Final Focused Feasibility Study Report
Ground Water Remediation

Shieldalloy Metallurgical Corporation
Newfield, New Jersey

Prepared by:
TRC Environmental Corporation

April 1993
Revision 1: June 1993
Revision 2: February 1994

FIGURE 3-11.
TOTAL CHROMIUM CONCENTRATIONS (PPB)
DEEP WELLS
DECEMBER, 1990

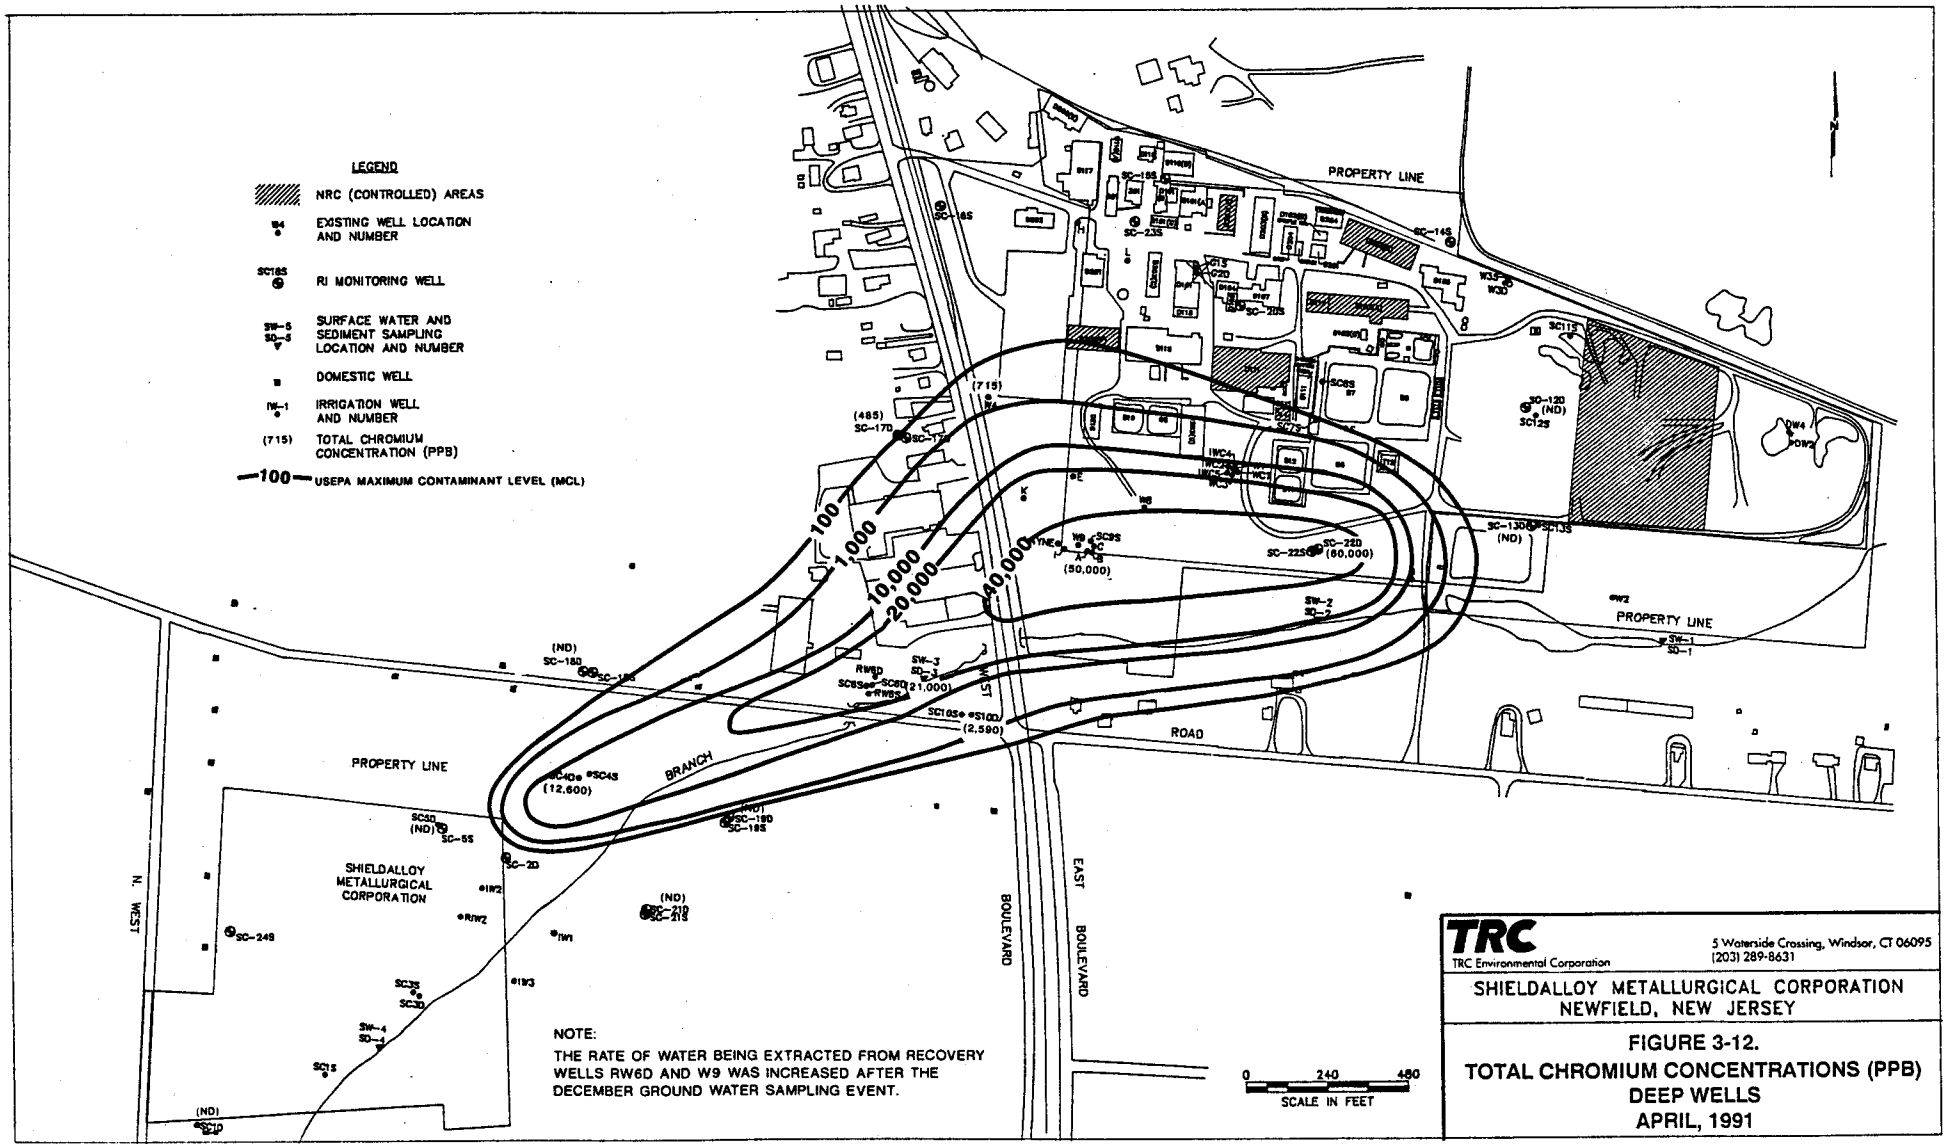
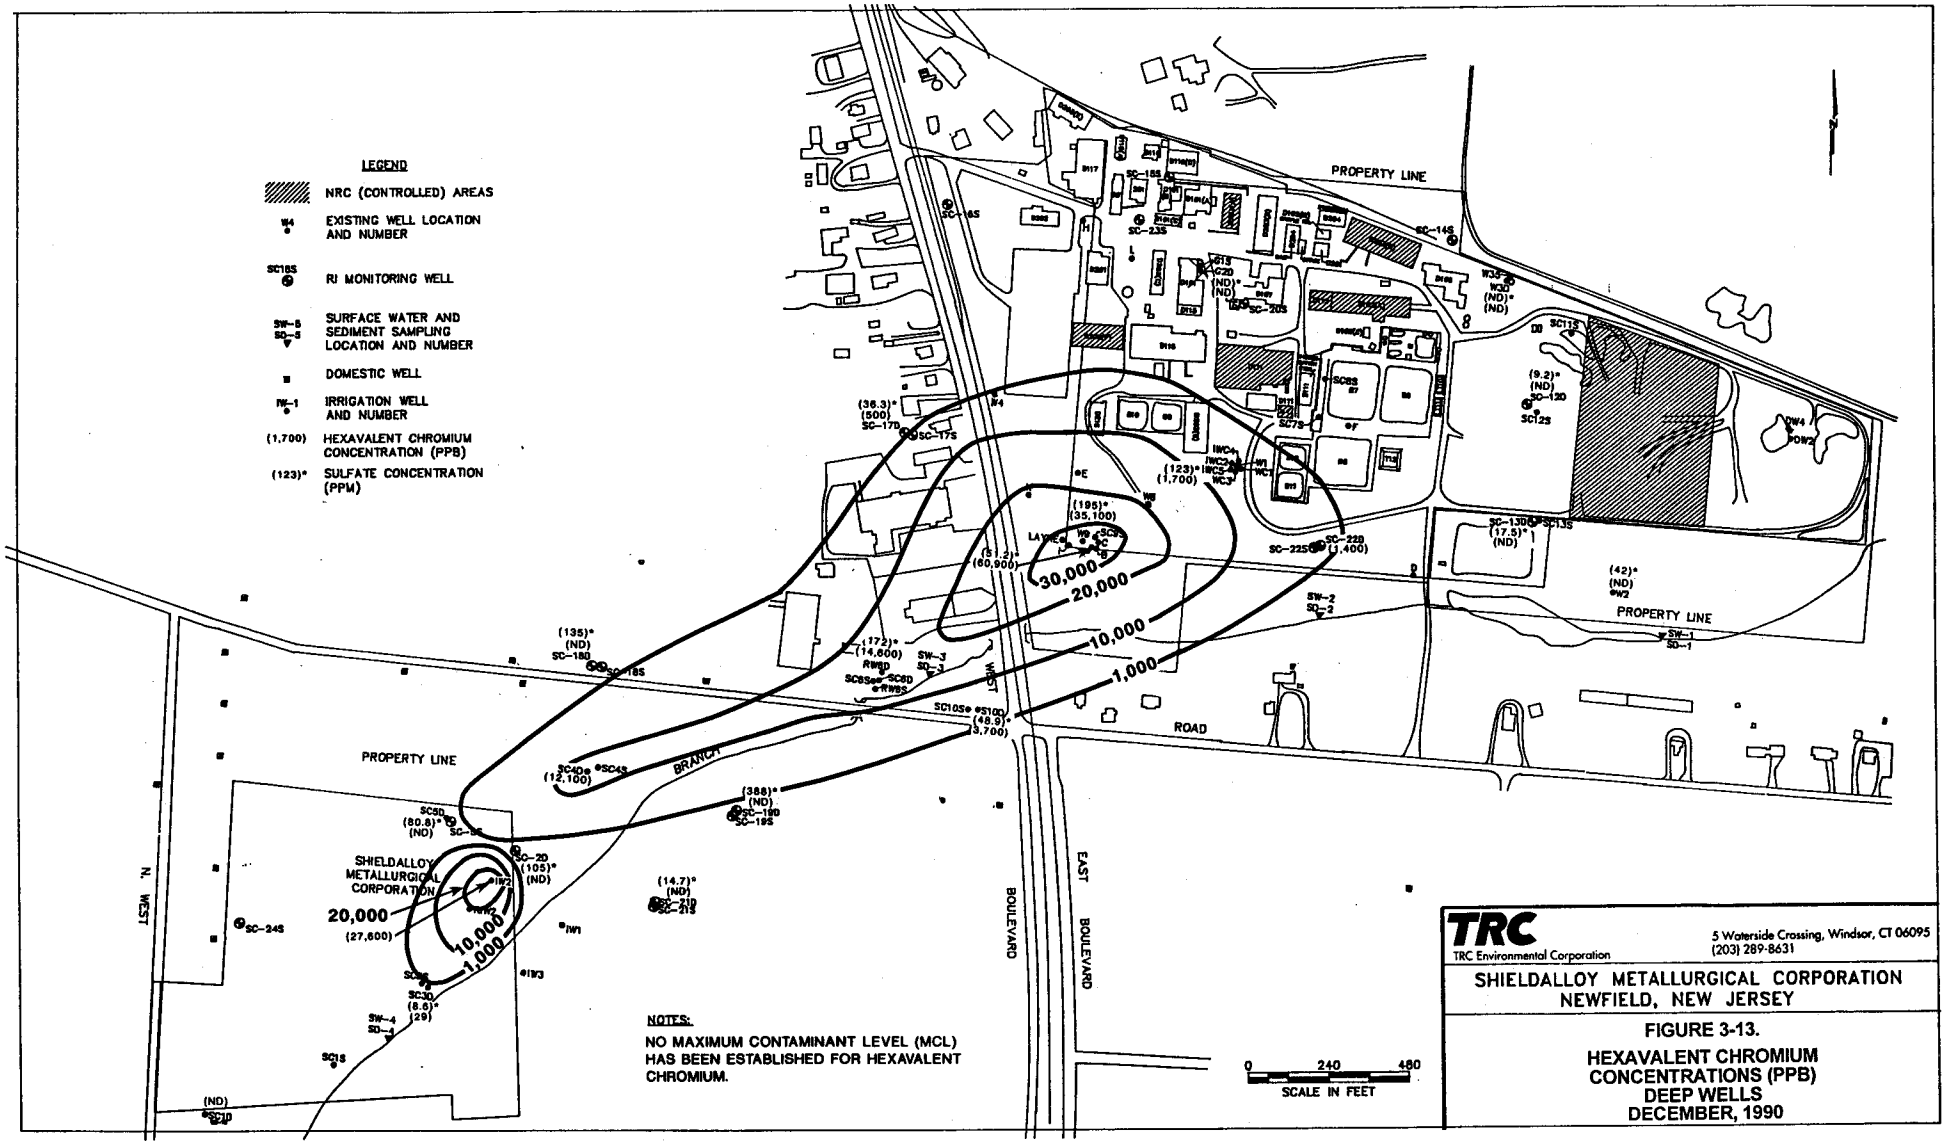
A more useful exercise would have been presenting an explanation for the major differences in concentration in the deep zone at the far southwest part of the plume. No explanation is offered for the major change in concentration of total Cr in the deep wells noted between December 1990 and April 1991 (see Figures 3-11 and 3-12).
